WORK PLAN ADDENDUM 25
RCRA FACILITY INVESTIGATION
WORK PLAN:

TCE Plume at Bldgs 1549, 1041,
and 1034 (RAAP-047)

**Comments and Responses on the
Draft Final RFI Work Plan for TCE PLUME AT BLDGS 1549, 1041, AND 1034 (RAAP-47)**

SUBJECT: RAAP Technical Review of the WPA 25 RFI Draft
Work Plan, dated March 2008, for the TCE Plume at
Buildings 1549, 1041, 1034 (RAAP-047)

Figure 4
Flow Chart
RAAP-047, Radford Army Ammunition Plan

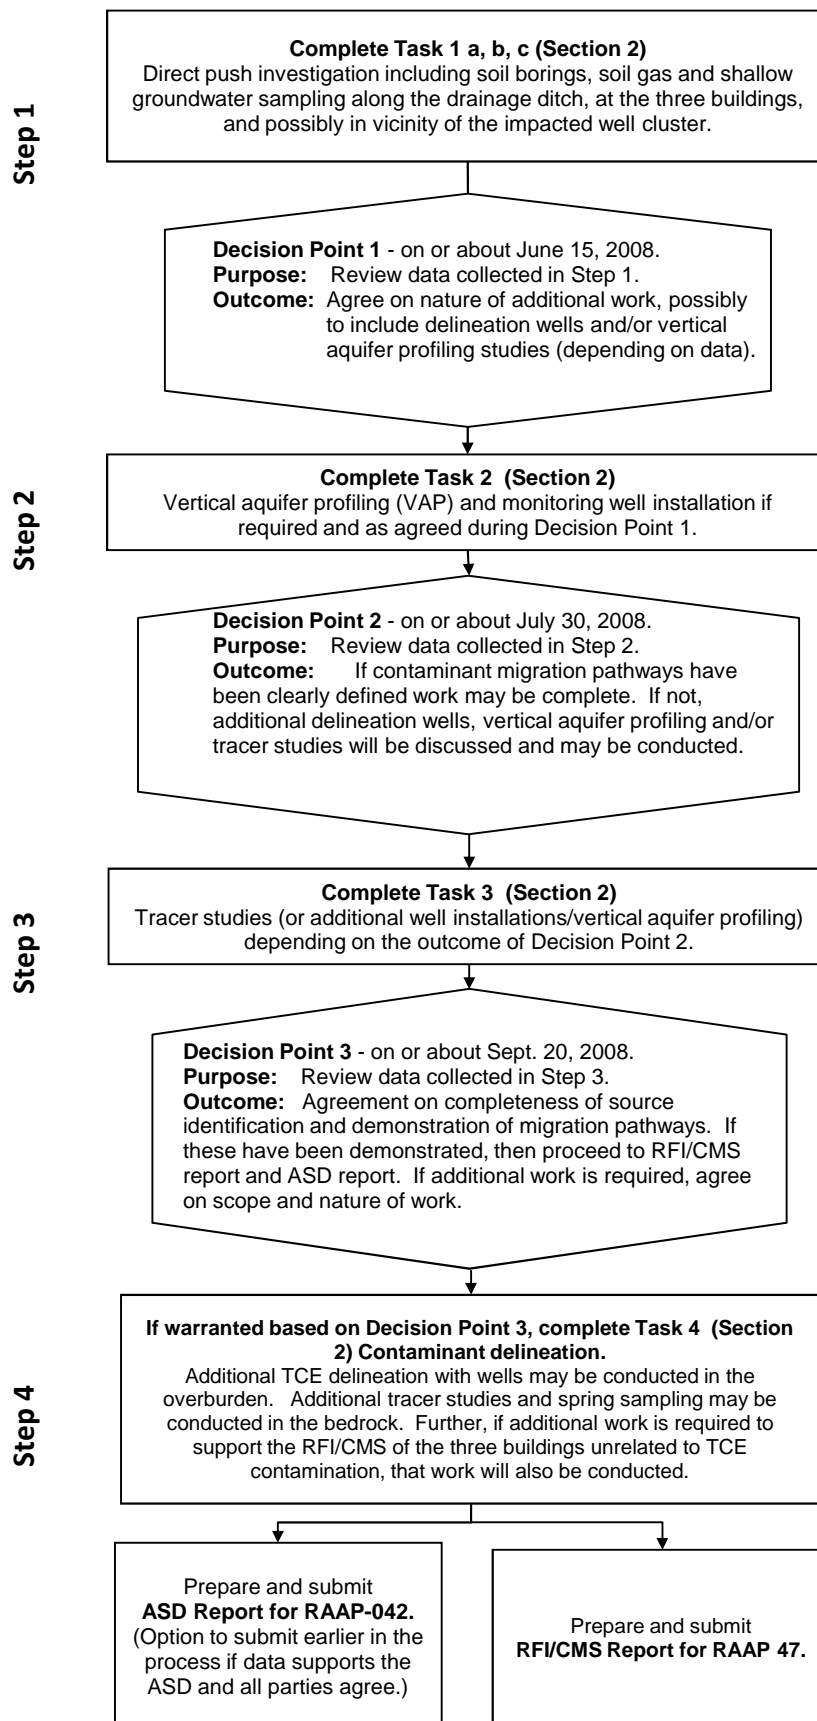
Item No.	Report Reference	COMMENT	RESPONSE
13	Figure 4	Figure 4 should be revised to show a separate ASD report, as well as data evaluation and possible data collection around the impacted wells at HWMU 5.	Agreed. Figure 4 has been revised to indicate possible data collection between HWMU-5 and the impacted wells.
14	SOP 3	Standard Operating Procedure No. 3 (SOP 3) does not reflect site conditions. SOP 3 should be revised to reference alluvium, epikarst, and bedrock at 15 to 50 ft bgs instead of till and bedrock at 60-65 ft bgs. There should be a reference or description of a procedure for dealing with immiscible layers.	Agreed. SOP has been revised to reference alluvium/overburden rather than till. In addition the depths to bedrock were revised to be 15 to 50 ft bgs.
Commenter: Michael Cramer (EPA)			
1	General	Although the cover title of the document makes reference to a RCRA Facility Investigation (RFI), the Introduction characterizes the document as an RFI/CSM (sic). Since no corrective measures are proposed, this document should not be characterized as a CMS.	This document was intended to be a work plan for collecting the data necessary to complete both the RCRA Facility Investigation and the Corrective Measures Study. However, for clarification purposes, references to the CMS have been deleted where appropriate.

1. Figure 3 Boring locations shown don’t exactly match location descriptions on page 5 and page 9. Either the figure or the text need to be revised.
2. Figure 4 should be revised to show a separate ASD report, as well as data evaluation and possible data collection around the impacted wells at HWMU 5.
3. Standard Operating Procedure No. 3 (SOP 3) does not reflect site conditions. SOP 3 should be revised to reference alluvium, epikarst, and bedrock at 15 to 50 ft bgs instead of till and bedrock at 60-65 ft bgs. There should be a reference or description of a procedure for dealing with immiscible layers.
